FILE P. I. No. 0007547, Henry County
CSHPP-0007-00(547)
SR 81 @ CR 452/Lake Dow Road-
Intersection Improvements

SUBJECT APPROVED REVISED PROJECT CONCEPT REPORT

SUBJECT **REVISED PROJECT CONCEPT REPORT**

REVISED PROJECT CONCEPT REPORT

TYPICAL SECTION LAKE DOW ROAD

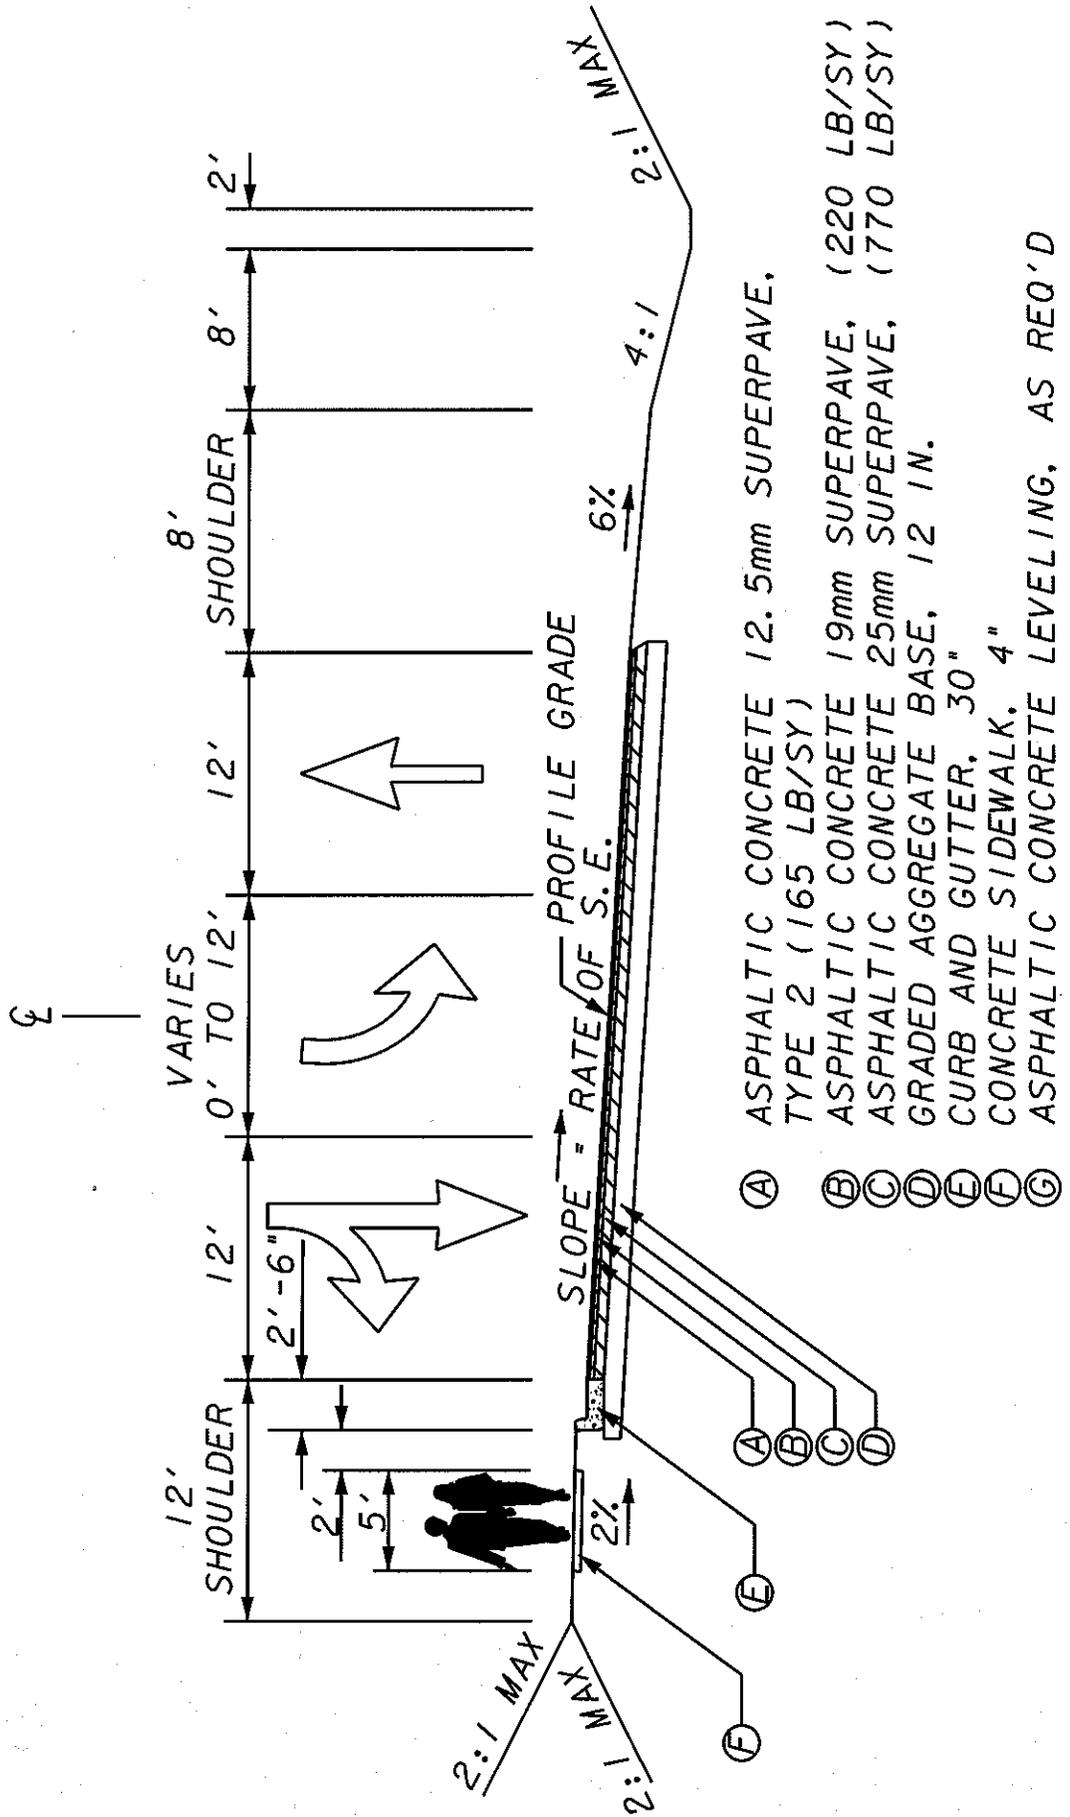
- Typical Section:
 - **Lake Dow Road:** One twelve feet wide through lane in each direction, twelve feet wide left and right turn lanes with curb and gutter and five feet sidewalk.

This feature needs to be revised because the Approved Concept Report stated the lane configurations incorrectly. The layout was correct and provided for a 3-lane section rather than the 4-lane section described in the Approved Concept Report. A 4-lane section would create additional R/W costs which would be undesirable to the stakeholders involved.

- Typical Section:
 - **Lake Dow Road:** One twelve feet wide through lane eastbound, one twelve feet wide left turn lane westbound, and one shared through/right lane westbound with curb and gutter and five feet wide sidewalk.
